Subject: Transmittal of Revision 1 Service Bulletin Number V2500-NAC-78-0186

Number: V2500-NAC-78-0186, Revision No. 1

SUBJECT: COMMON NOZZLE ASSEMBLY (CNA) ACAC EXHAUST EXIT AREA MODIFICATION/
THRUST RECOVERY DUCT MODIFICATION

Thrust Recovery Duct Modification and New Cover
Figure 1 (sheet 2)

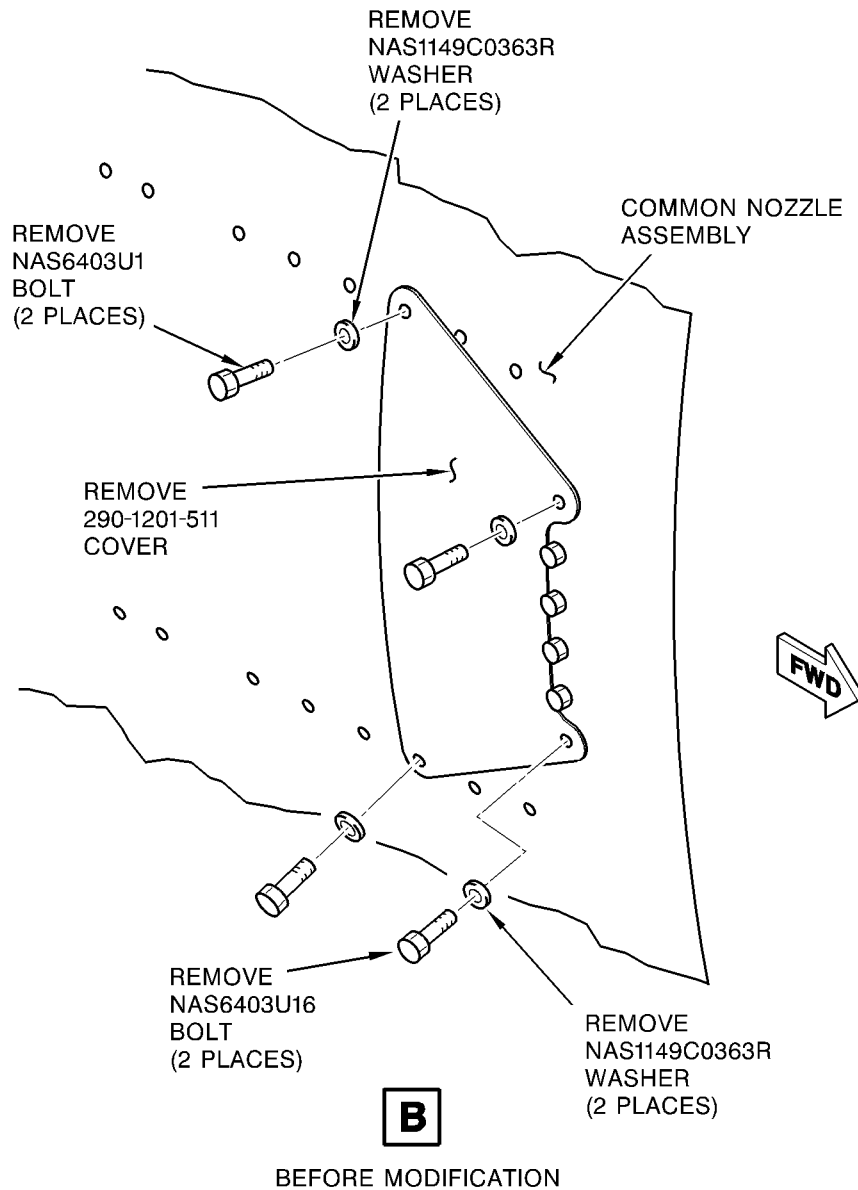
- (1) Open the thrust reverser halves. Refer to the MD-90 Aircraft Maintenance Manual.
- (2) Remove the bolts and thrust recovery duct from the CNA. Refer to Figure 1 (sheet 1).
- (3) For uninstalled CNAs, remove the bolts, washers and the 290-1201-511 cover from the opposite side of the CNA. Refer to Figure 1 (sheet 2).
- (4) Remove the ACAC duct from the CNA (if necessary for access). Refer to Figure 2 (sheet 1).
 - a. For installed CNAs, remove the clamp, the seal, and the ACAC duct from the duct on the engine.
 - b. Remove the bolts, washers, spacers, and ACAC duct from the bracket.
 - c. Remove the clamp, the seal, and the ACAC duct from the CNA.
- (5) Remove the bolts and the fairing and shim (if any) from the CNA.

Thrust Recovery Duct Modification and New Cover
Figure 1 (sheet 3)

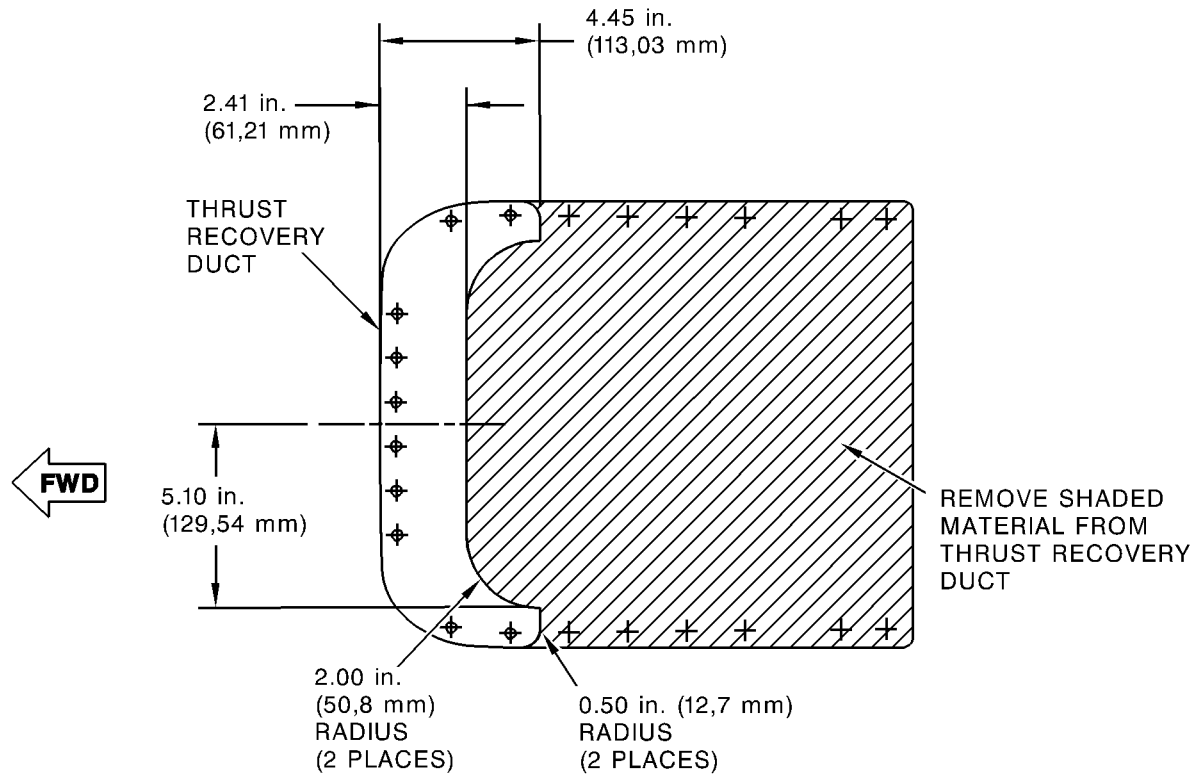
B. Modify the Thrust Recovery duct. Refer to Figure 1 (sheet 3).

- (1) Clean the thrust recovery duct with solvent (CoMat 01-438) and a clean lint free cloth (CoMat 02-099). Wipe the thrust recovery duct dry before the solvent becomes dry.
- (2) Remove the indicated material from the thrust recovery duct. Remove any burrs and sharp edges.

- (3) Re-identify the 290-1273-505 thrust recovery duct as the 290-1273-507. Use a rubber stamp and ink (CoMat 06-073). Refer to the Standard Practices /Processes Manual, Chapter 70-09-00.

Thrust Recovery Duct Modification and New Cover
Figure 1 (sheet 4)

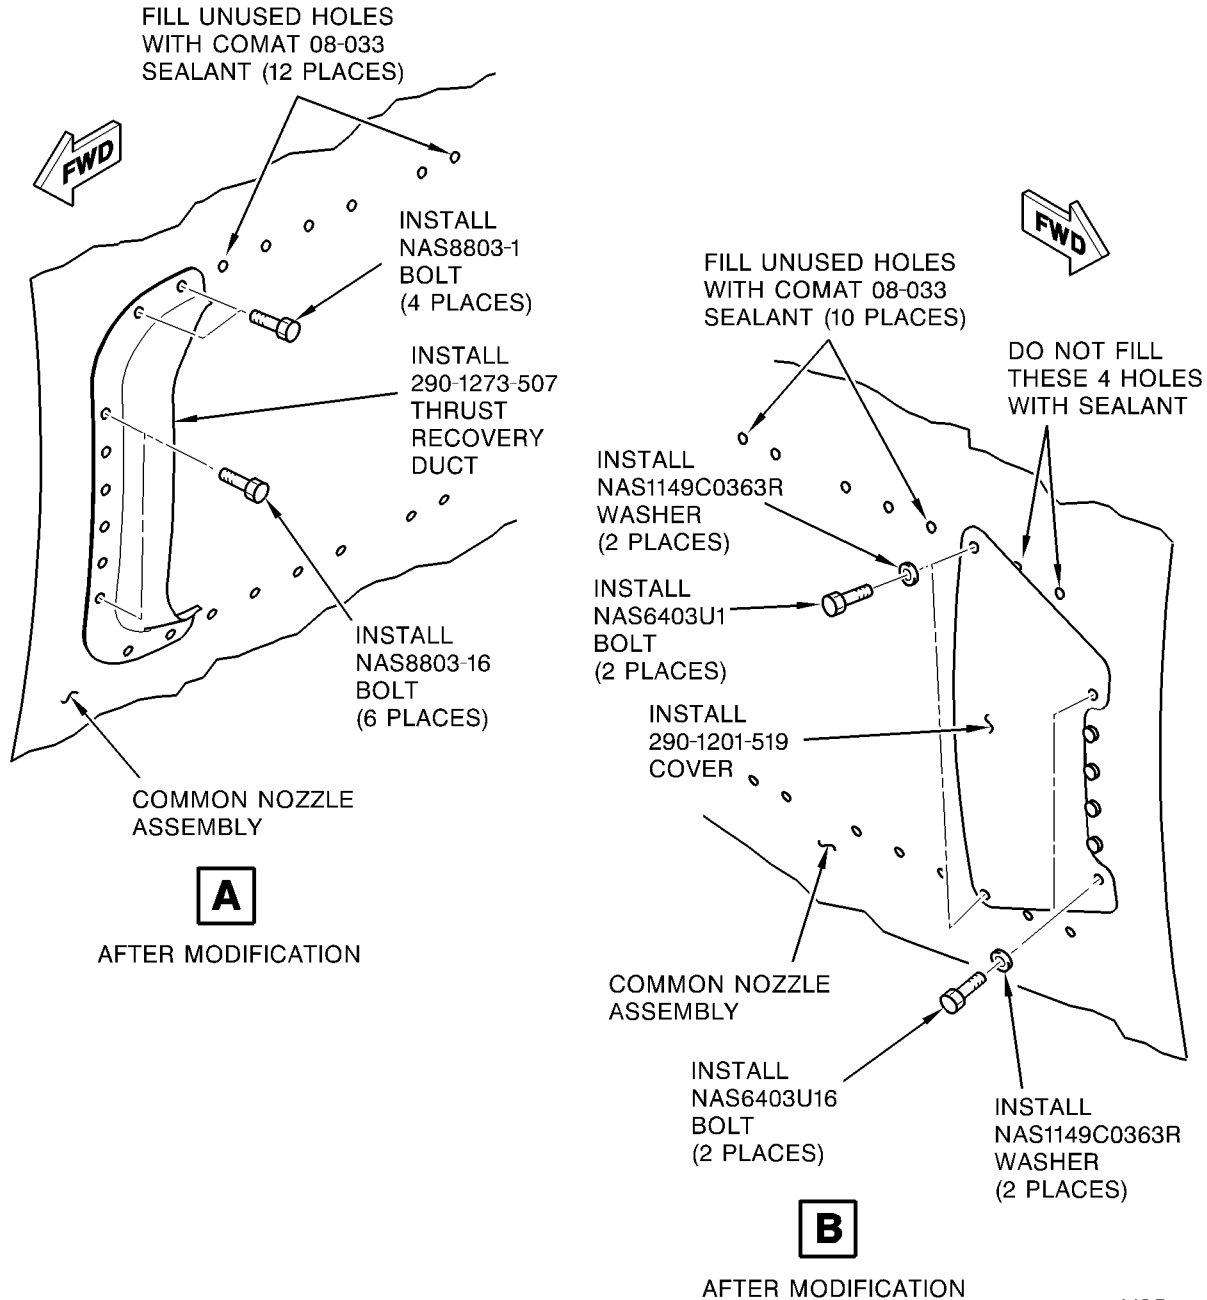
- (3) Install the thrust recovery duct. Refer to Figure 1 (sheet 4).
- a. Apply primer (CoMat 08-032) to the mating surfaces of the 290-1273-507 thrust recovery duct and the CNA. Refer to the manufacturer's instructions.

- (4) For uninstalled CNAs, install the 290-1201-519 cover on the opposite side of the CNA with the washers and bolts. Refer to Figure 1 (sheet 4).
- (5) Fill the unused attach holes with sealant. Refer to Figure 1 (sheet 4).

- b. Apply sealant (CoMat 08-033) to the mating surfaces of the thrust recovery duct and the CNA. Refer to the manufacturer's instructions.
 - c. Install the thrust recovery duct on the CNA with the bolts.

- d. Apply primer (08-032) to the edges of the thrust recovery duct. Refer to the manufacturer's instructions.
 - e. Apply sealant (CoMat 08-033) to the edges of the thrust recovery duct. Refer to the manufacturer's instructions.

- a. Apply primer (CoMat 08-032) to the unused attach holes. Refer to the manufacturer's instructions.
 - b. Fill the unused attach holes with sealant (CoMat 08-033). Refer to the manufacturer's instructions. Refer to Figure 1.

CNA ACAC Exhaust Area Modification
Figure 2 (sheet 1)

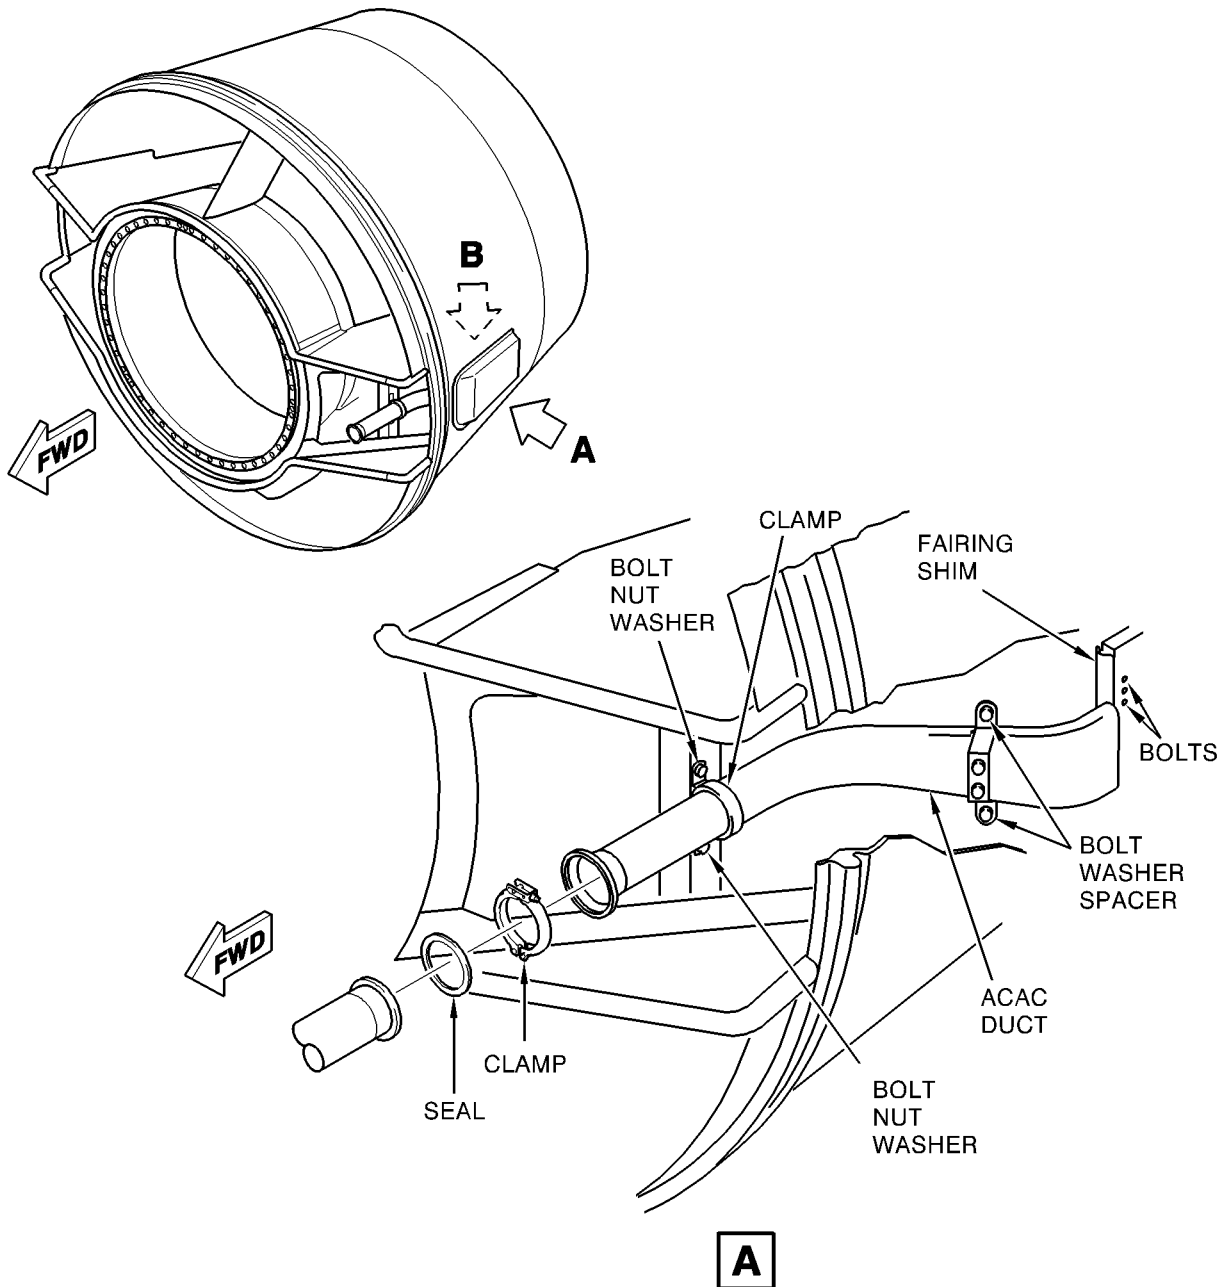
- (1) Install the fairing and shim (if any) on the CNA with the bolts. Refer to Figure 2 (sheet 1).
- (2) Install the ACAC duct (if removed). Refer to Figure 2 (sheet 1).
 - a. Attach the ACAC duct to the C.N.A. with the bolts, washers, and spacers.
 - b. Attach the ACAC duct to the C.N.A. with the clamp, bolts, washers, and nuts.
 - c. For installed CNAs, attach the ACAC duct to the duct on the engine with the seal and the clamp.
 - d. Torque the clamp to 115-125 inlb (13-14 N.m).
 - e. Tap around the outside of the clamp with a soft faced hammer.
 - f. Torque the clamp again to 115-125 inlb (13-14 N.m).
 - g. Tap around the outside of the clamp with a soft faced hammer.
 - h. Torque the clamp again to 115-125 inlb (13-14 N.m).
 - i. Torque the bolts to 20-25 inlb (2-3 N.m).

CNA ACAC Exhaust Area Modification
Figure 2 (sheet 2)

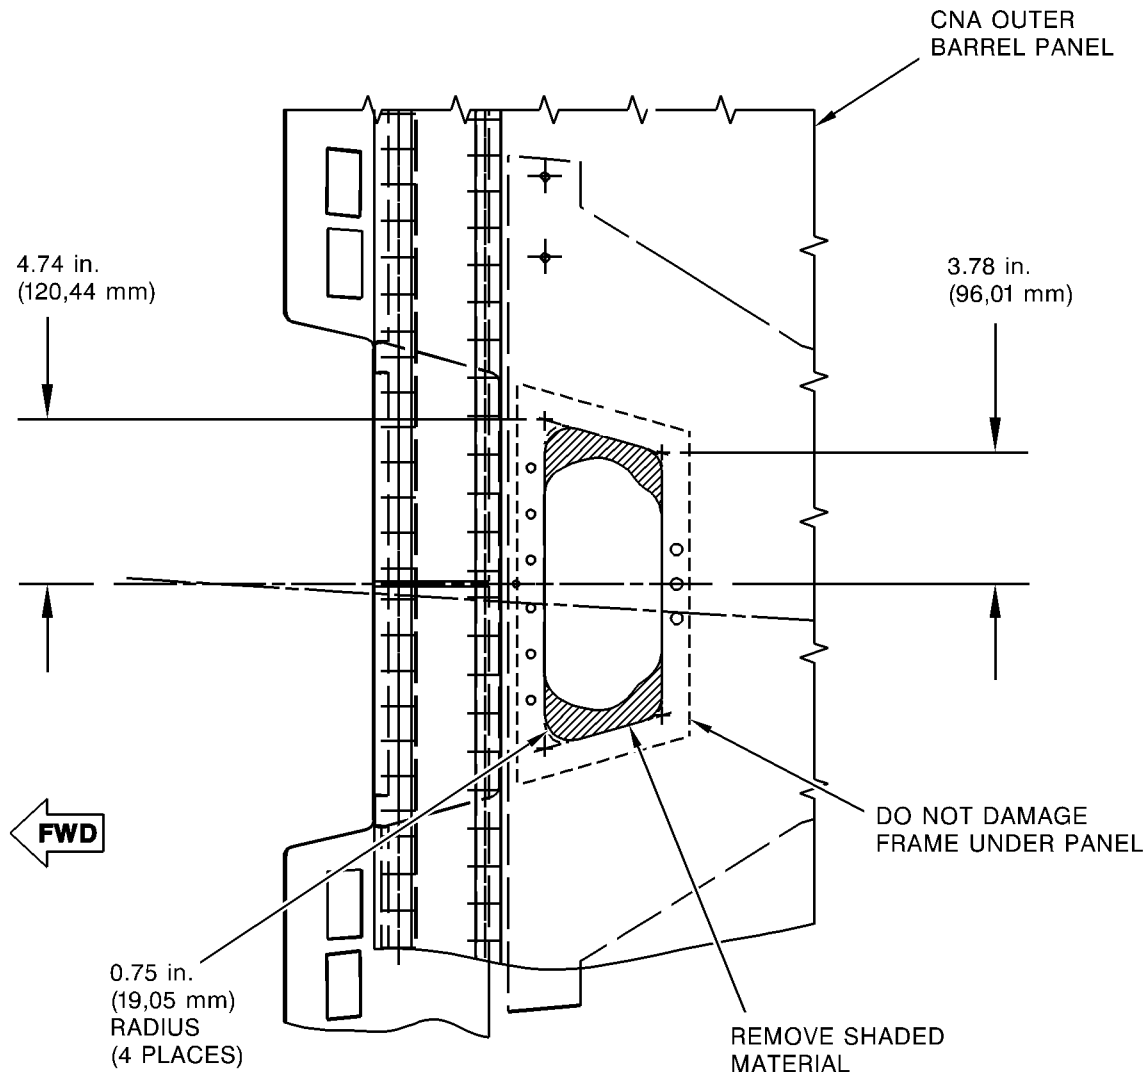
C. Make the CNA ACAC Exhaust Area Larger. Refer to Figure 2 (sheet 2).

CAUTION: THE MATERIAL REMOVAL DIMENSIONS SHOWN IN FIGURE 2 ARE APPROXIMATE. MAKE SURE YOU DO NOT DAMAGE THE FRAME THAT IS UNDER THE PANEL.

- (2) Remove the indicated material from the CNA. Remove any burrs and sharp edges. Remove all particles and debris.
- (3) Clean the modified area of the CNA with solvent (CoMat 01-438) and a clean lint free cloth (CoMat 02-099). Wipe the area dry before the solvent becomes dry.

- (4) Apply primer (CoMat 08-032) to the exposed core in the modified area of the CNA. Refer to the manufacturer's instructions.

- (5) Apply sealant (CoMat 08-033) to the exposed core in the modified area of the CNA. Refer to the manufacturer's instructions.
- (6) Re-identify the 290-1201-515 common nozzle assembly as the 290-1201-517. Use metal stamp, vibroetch or electroetch method. Refer to the IAE V2500 Standard Practices/Processes Manual, Chapter 70-09-00.
